Final Drainage Report
for
Rolling Hills Ranch Filing 2
at
Meridian Ranch

EL PASO COUNTY, COLORADO

November 2020

PCD Project No. SF-20-020

FIGURE 4

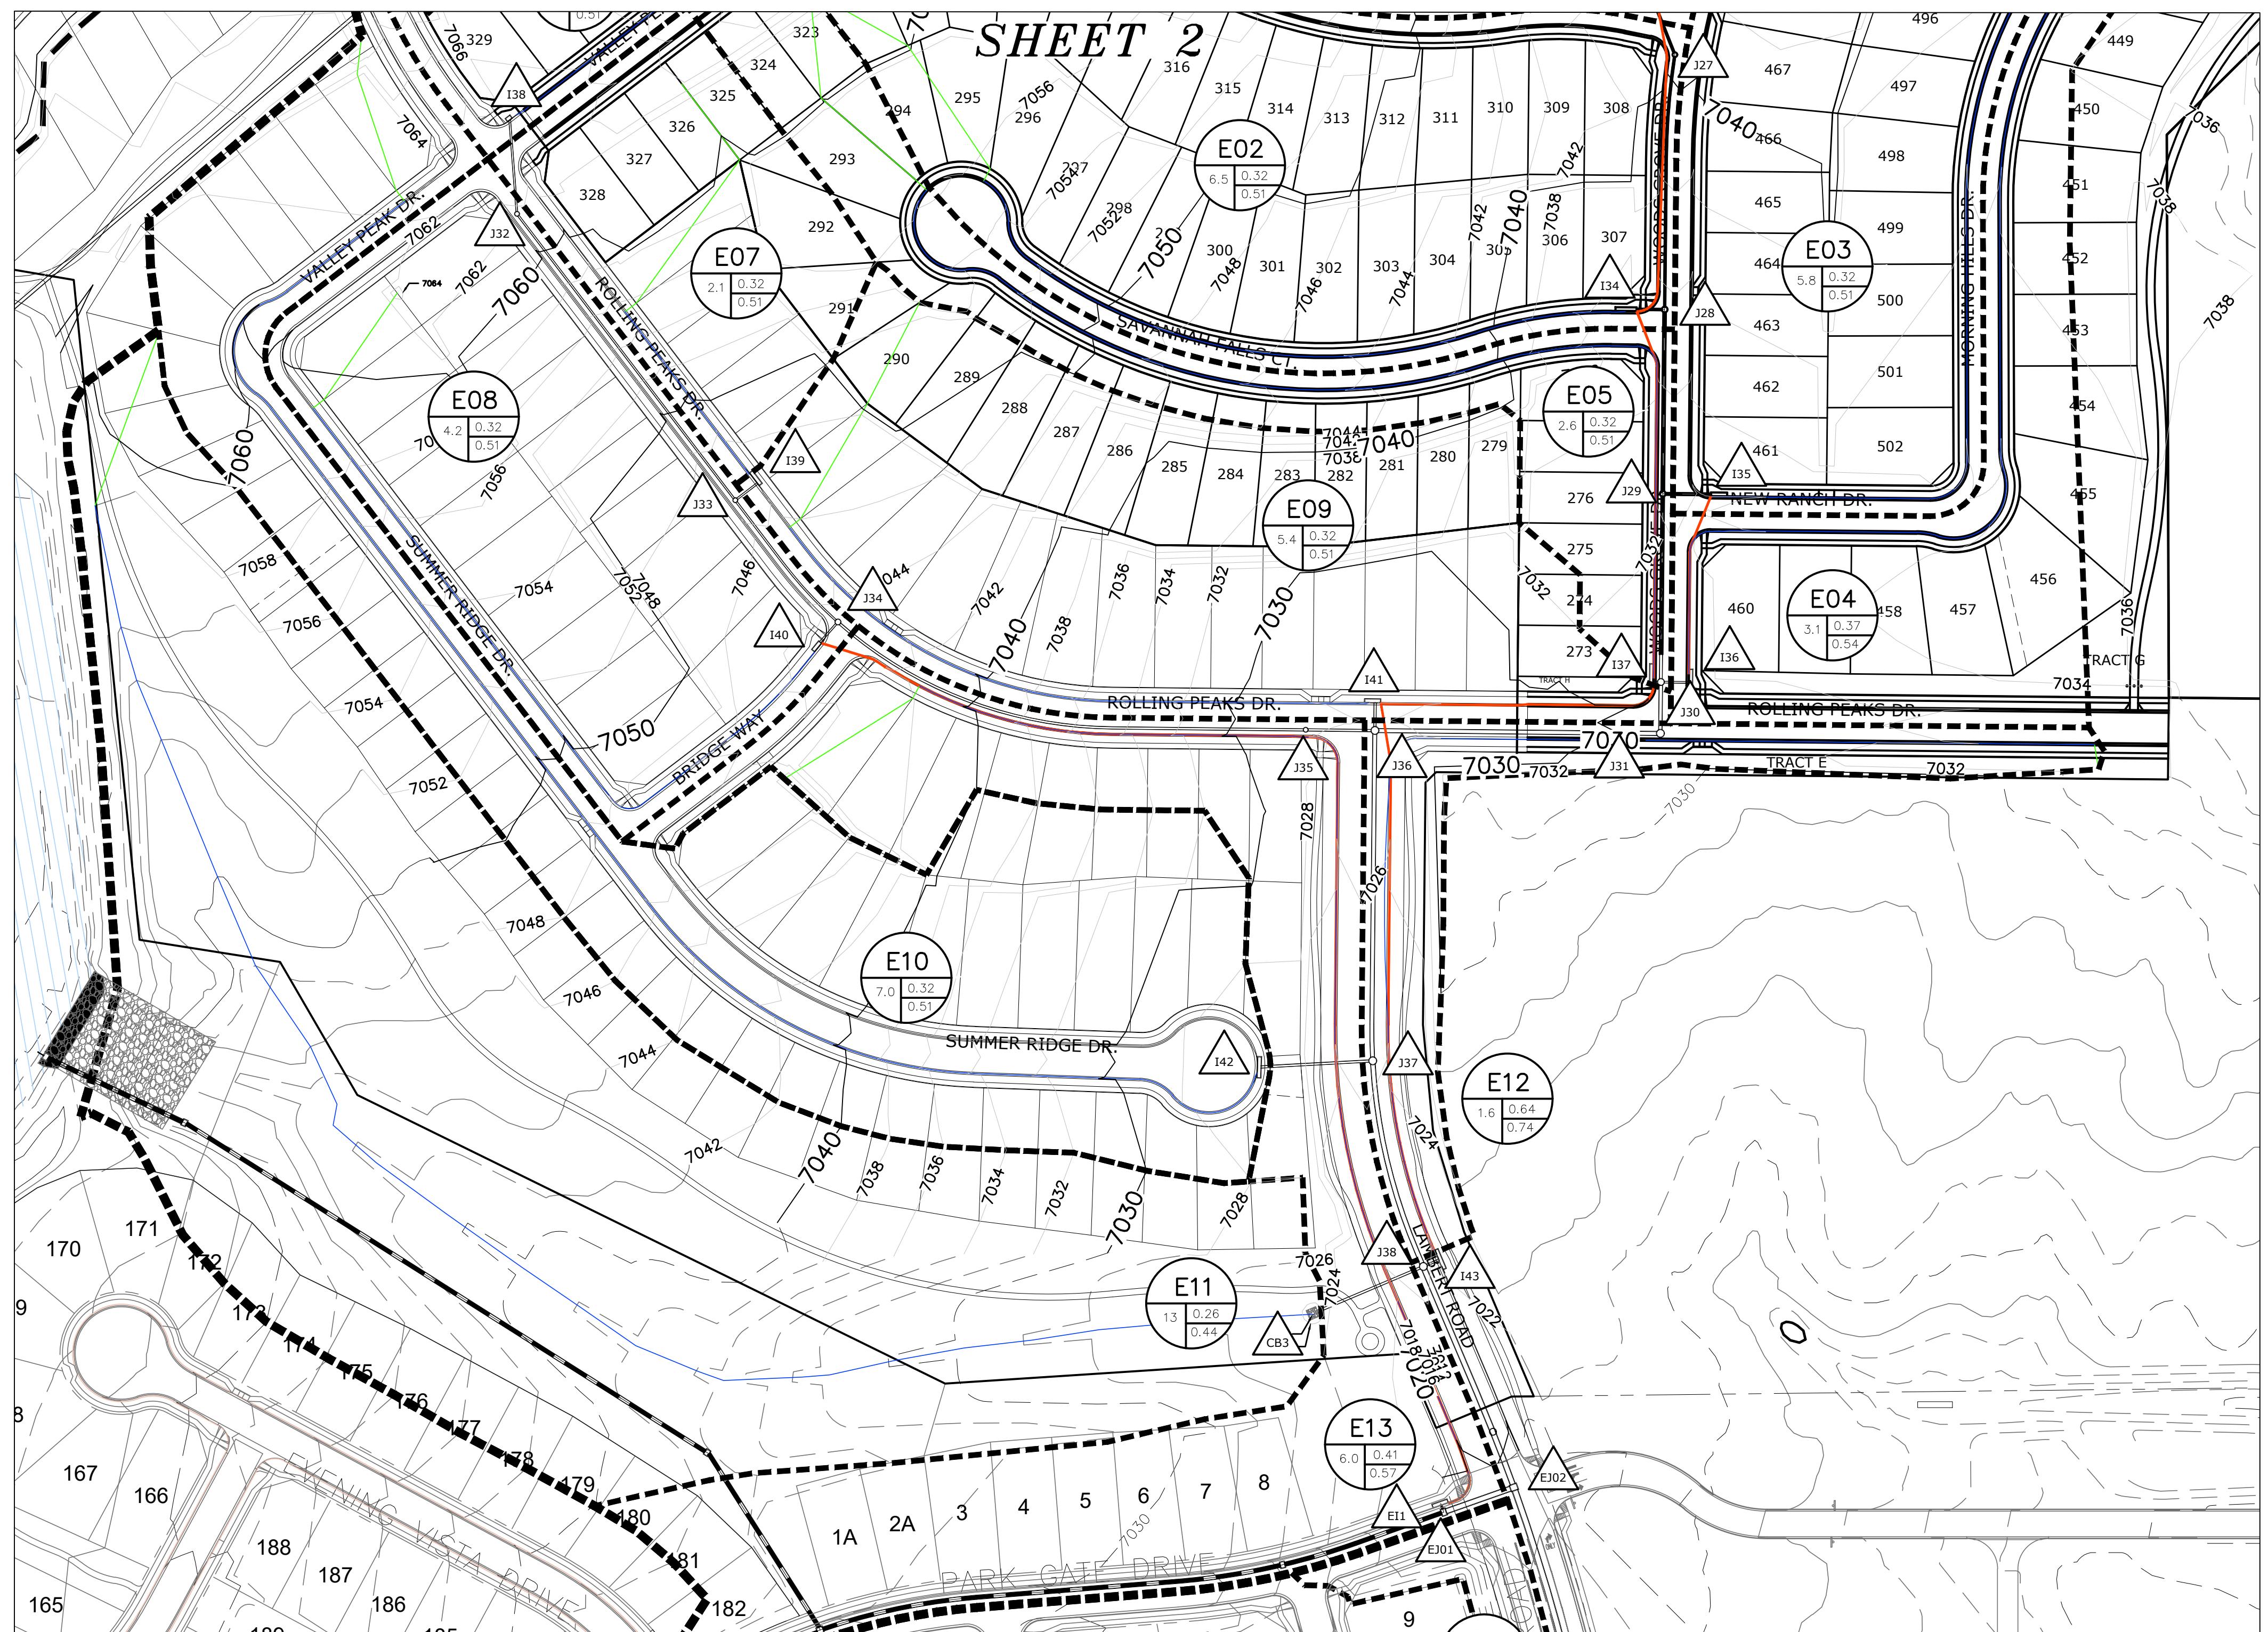
Previous comments were provided on the CD (sheet 8). It appears that the storm sewers on the CD's match the hydraulics calculations but not the pipe routing calculations and table on the drainage map. Please revise so that they are consistent.

The pipe routing calcs. indicate 18". So does the Table on the drainage map. Revise accordingly.

The pipe routing calcs. indicate a 36" pipe. So does the drainage map. Please revise the pipe routing calcs and drainage map so that they are consistent with the hydraulics calculations and CD.
